**SITE PLAN REVIEW COMMITTEE  
MEETING AGENDA**

**DATE:** Monday, July 2, 2012  
**TIME:** 7:00 – 10:00 p.m.  
**PLACE:** 2100 Clarendon Boulevard  
Courthouse Plaza, Rooms 109/111  
Arlington, VA 22201

**Item 1. Colony House/1700 Lee Highway (SP #423) 7:00 pm-8:30 pm**  
(RPC# 16-025-008)  
Planning Commission and County Board meetings to be determined.  
*Elizabeth Kays (CPHD Staff)*

**Item 2. 3901 N. Fairfax Drive (SP #386 – Design Concept for Public Plaza and 10<sup>th</sup> Street North) 8:30 pm-10:00 pm**  
No Planning Commission and County Board meetings required.  
(RPC# s 14-030-057 and -058)  
*Sophia Fisher and Freida Wray (CPHD Staff)*

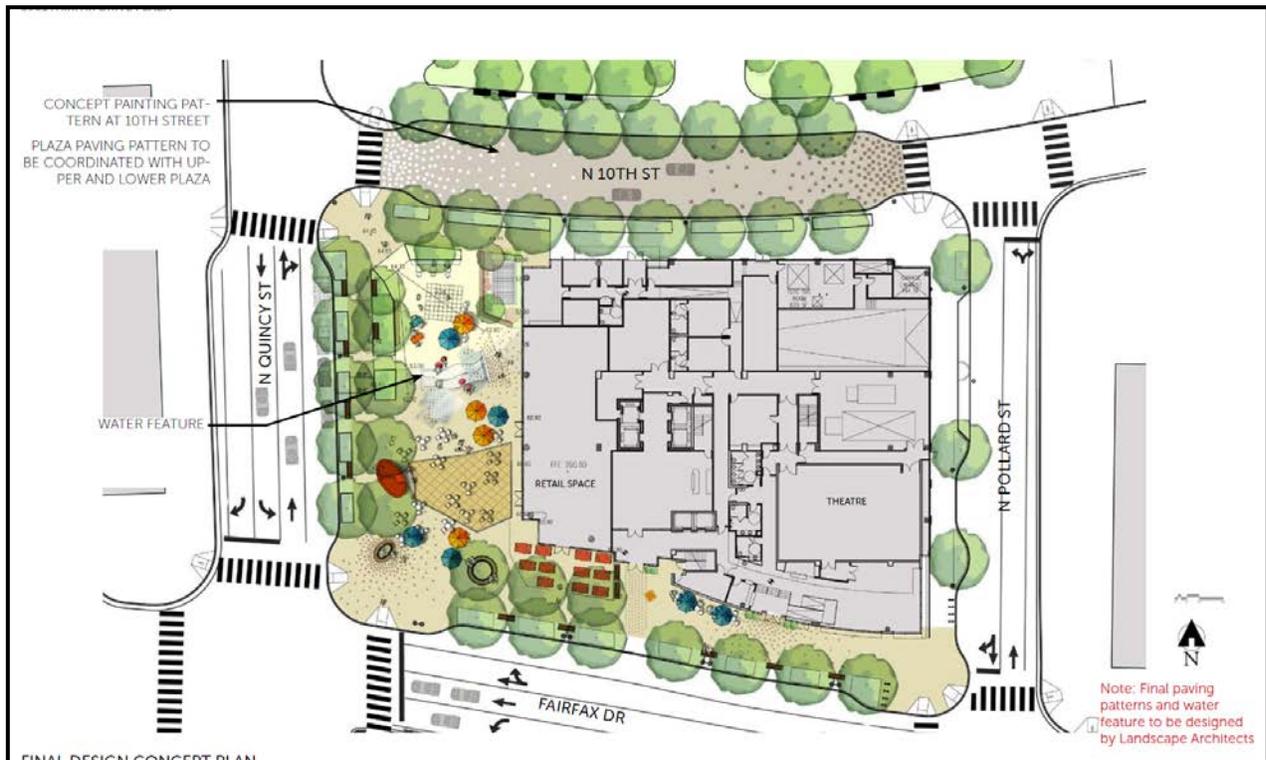
The PPS report outlined the following overall recommendations:

- Design the plaza so it can serve as a multifunctional, flexible, multipurpose public community space that is open, accessible and welcoming to everyone in the community.
- Expand the presence and influence of the Library.
- Create a visibly engaging gateway to Virginia Square and mark the delineation between Ballston and Virginia Square.
- Traffic calm 10<sup>th</sup> Street to create a seamless transition between the library and the plaza.

The report also outlined the key design elements for the plaza and 10<sup>th</sup> Street, which are summarized below:

- A two-level plaza with a large lower space on the south side and a smaller upper space along 10<sup>th</sup> Street; The lower main Plaza should be a multipurpose space with moveable tables and chairs and the upper level should be a more intimate location for classes or readings.

- An interactive water feature as the focal point of the main space, to be interactive, participatory, colorful, and engaging for all age groups including families and children. Water feature to be integrated into the grade change with a surface and raised water movement. Should be designed to be attractive even when not turned on as water feature.

#### Crimson's Revised Concept Design

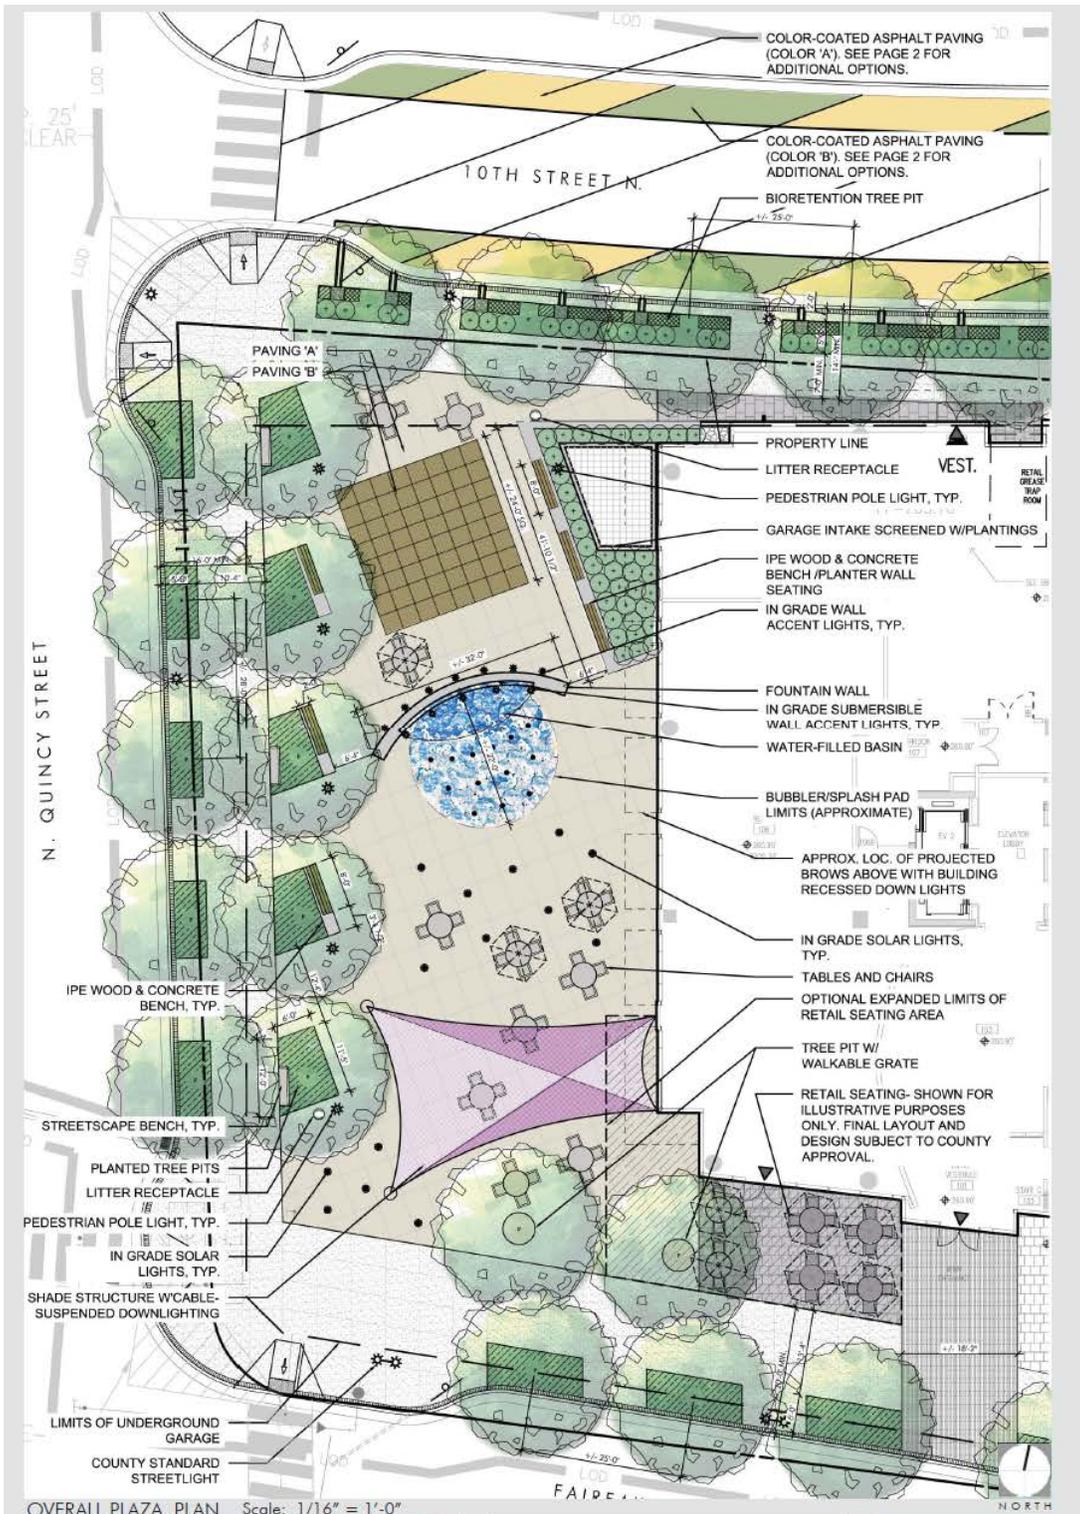
Staff continues to work with the developer to flesh out certain elements of the revised design concept, including the plaza paving, water feature and 10<sup>th</sup> Street design. An update will be provided at the SPRC meeting. The following documents are available SPRC website: the PPS Report and precedent images provided by the developer.
